February 12, 2010
Project No. 10-01-33

Re: Response to a TCEQ Notice of Deficiency Letter Dated January 14, 2010, Permit Modification – Groundwater Monitoring System, City of Kerrville Landfill, MSW Permit No. 1506A, Kerr County, Texas; WWC 11995264 and 12931524; RN102000551 / CN602452286

4-12

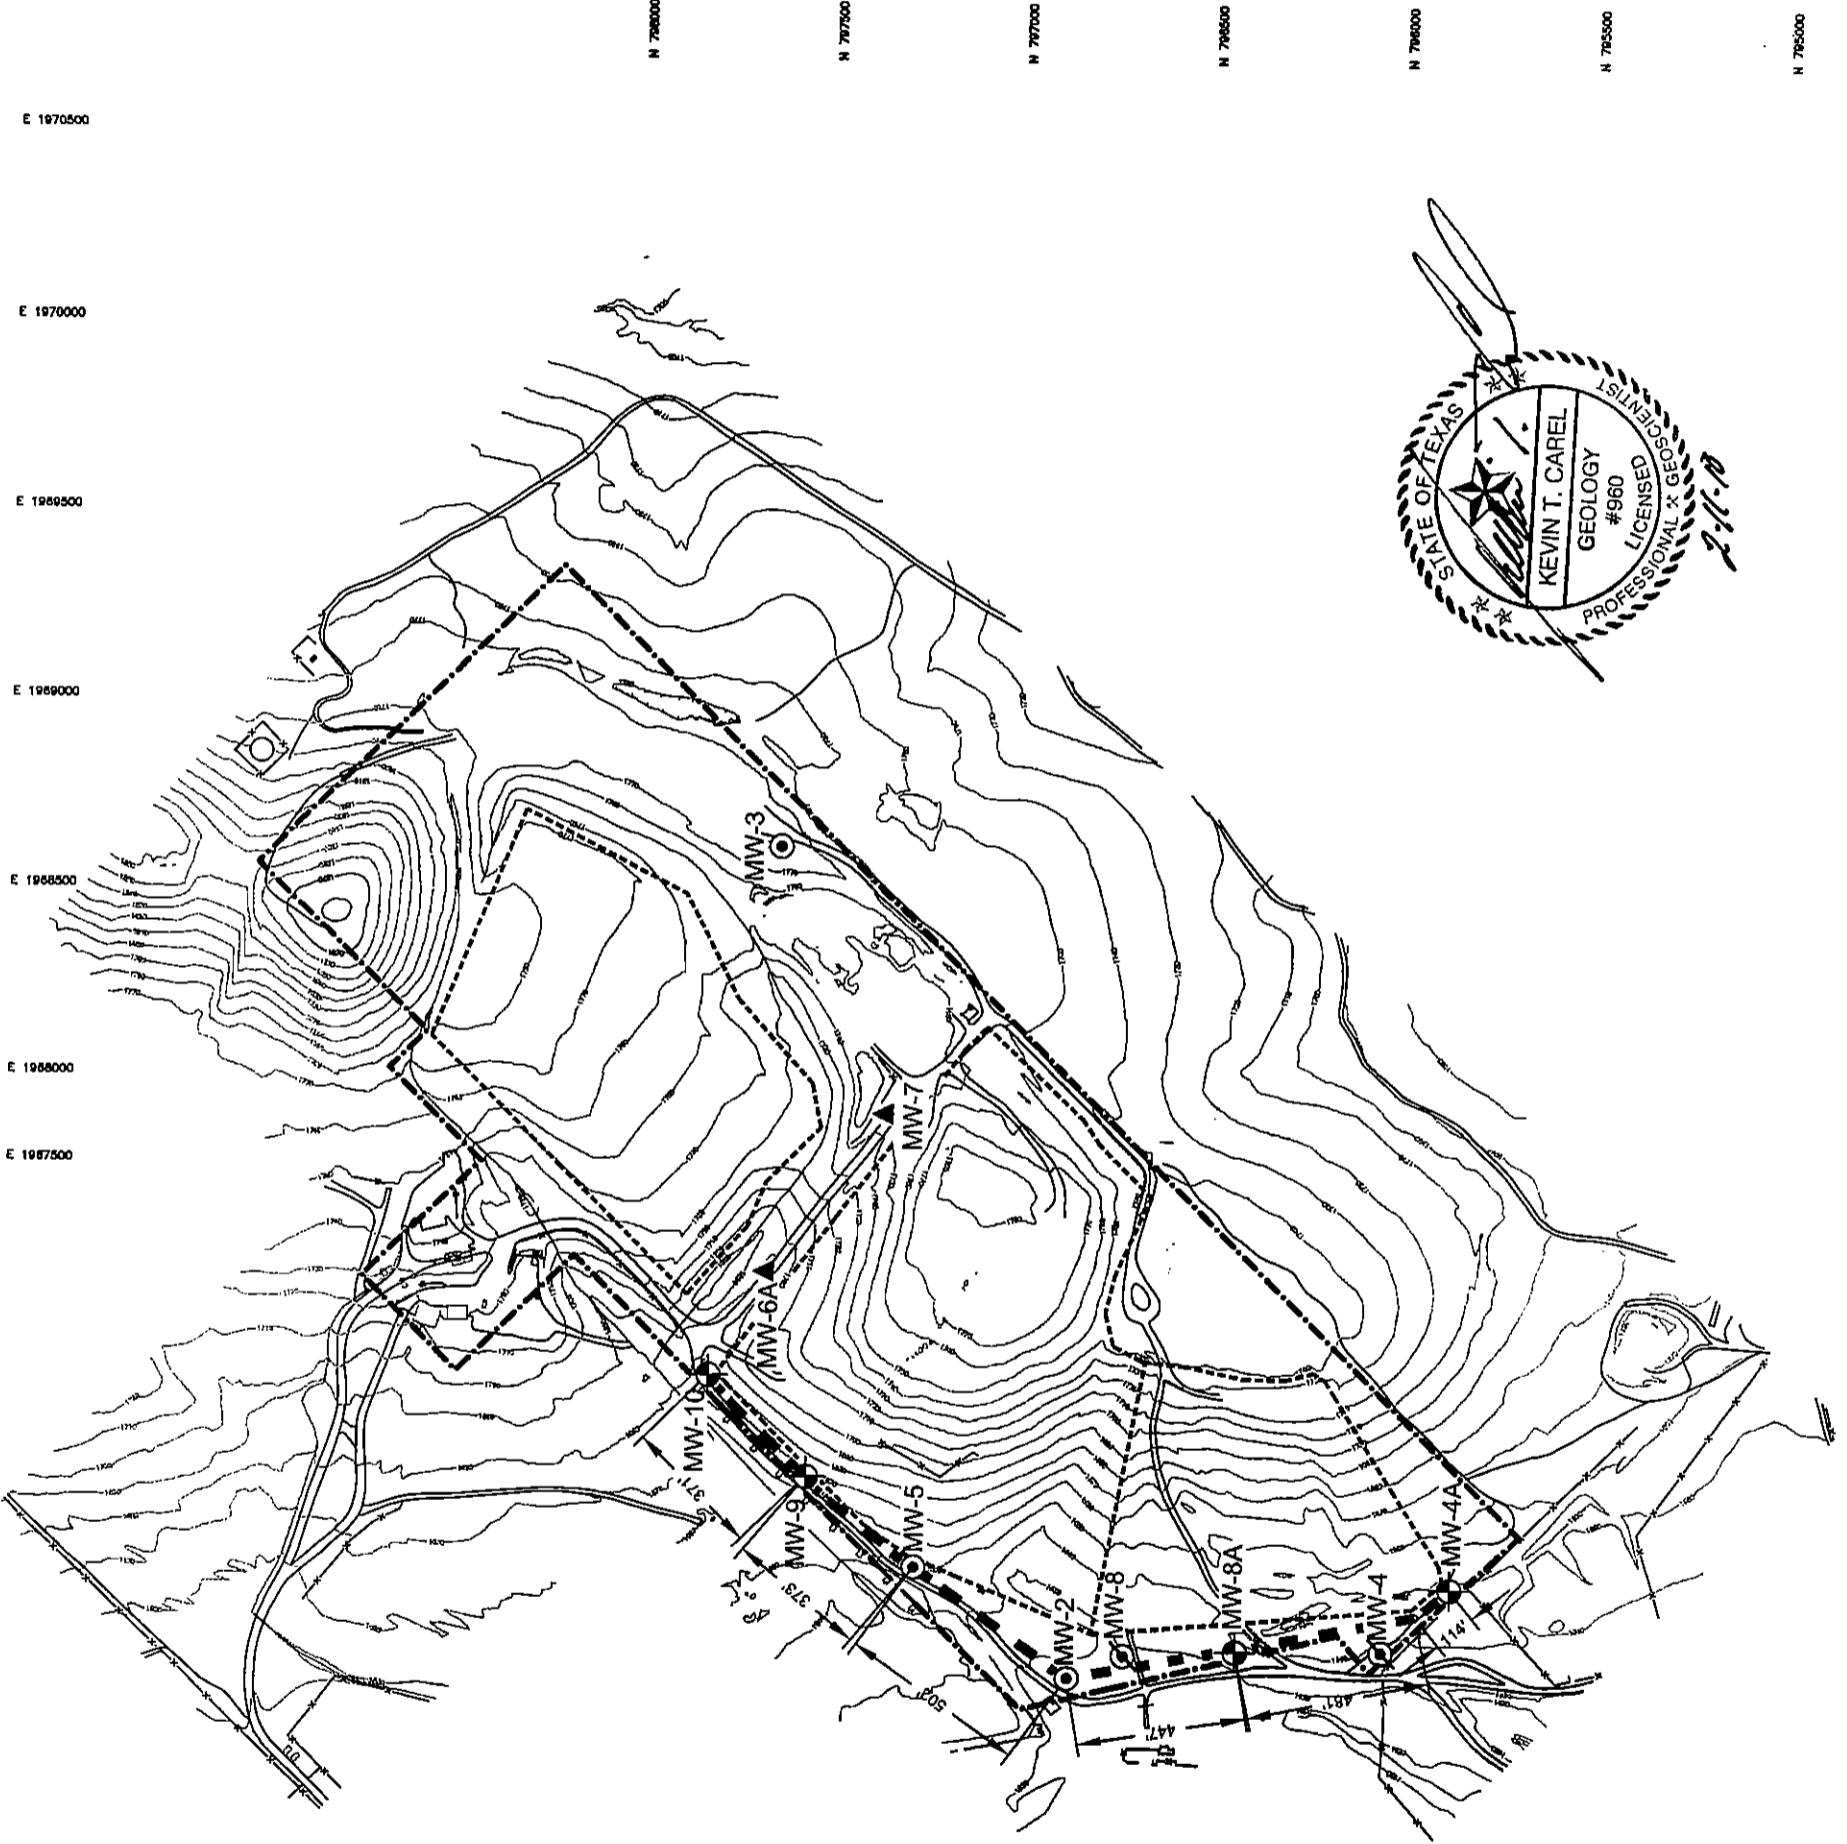
The revised POC does not extend far enough on the northwest side of the landfill to cover the entire area downgradient of the landfill. Please extend the POC northeastward past the proposed location of MW-9, include a well at the endpoint, and add one or more wells as needed to limit well spacing to not more than 600 feet along the POC.

Response: The POC has been extended northeast as requested and one more additional well (MW-10) is proposed. The text on page 4(6)-1 and Figure 4-12 of permit Attachment 4 has been revised accordingly.
